City of Coral Gables Board of Architects Staff Report

Property:**Ponce Park Residences****Applicant:**

Application:**Mixed Use Building****BOA Permit:**

AB-20-09-5335

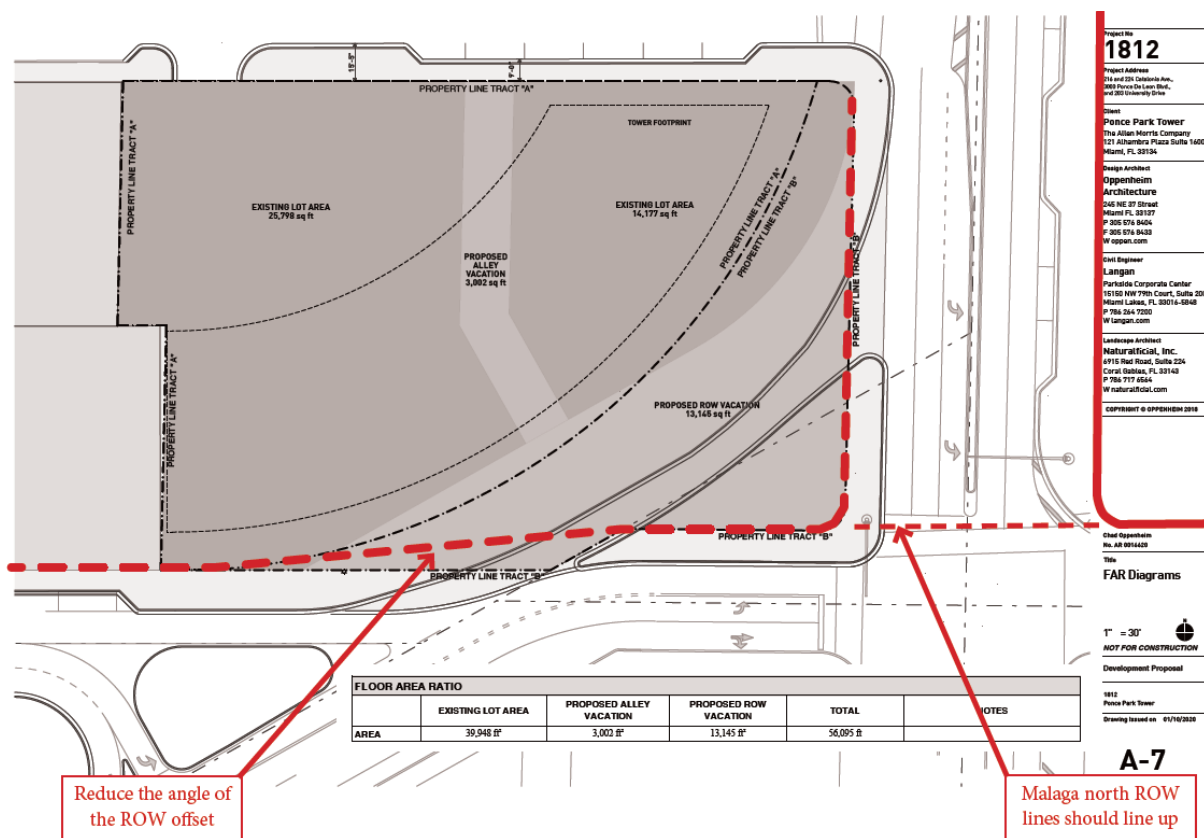
However, the proposed property lines of the tentative plat are not compatible with the existing rights of way of the area. Staff recommends two minor changes to be more consistent with the existing grid of the Crafts Section.

The proposed property line at the southeast corner may not be in-line with the north right-of-way line of Malaga Avenue across Ponce de Leon Boulevard. Unless designed with curves or angles, all street rights-of-way in the Crafts Section were designed to be in-line when crossing Ponce de Leon Boulevard. Staff recommends adjusting this corner to match the existing property line across Ponce de Leon Boulevard, as needed.

The south property line is proposed with a sharp corner that is presumably matching the existing centerline of University Drive. All blocks in the area are rectilinear in shape, except for significant curves facing Ponce de Leon Boulevard. Staff recommends modifying this south property line to create a block that is more compatible with the blocks in the city.

Below summarizes the two recommendations by Staff that create a new corner and property edge that is more compatible with the Crafts Section.

- a. Verify that southeast corner and property line is in-line with the existing north right-of-way line on Malaga Avenue across Ponce de Leon Boulevard. Adjust as needed.
- b. Adjust the south property line to improve the rectilinear shape of the proposed tentative plat and entire block.

CORAL GABLES MEDITERRANEAN DESIGN GUIDE BILTMORE HOTEL PRECEDENT

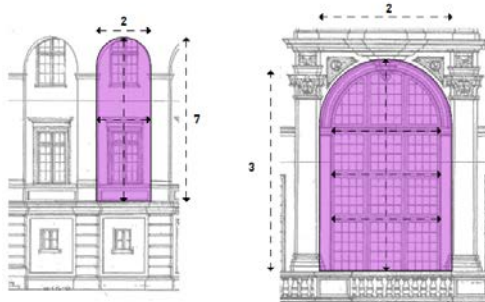
ARCH PROPORTION
 ARCH IS SLIGHTLY TALLER THEN THE 3:2 BILTMORE PROPORTION
 VERTICAL DIVISIONS SEEK TO MATCH BILTMORE PRECEDENT

ARCH PROPORTION
 ARCH PROPORTION MATCHES 7:2 BILTMORE PROPORTION
 VERTICAL DIVISIONS SEEK TO MATCH BILTMORE PRECEDENT
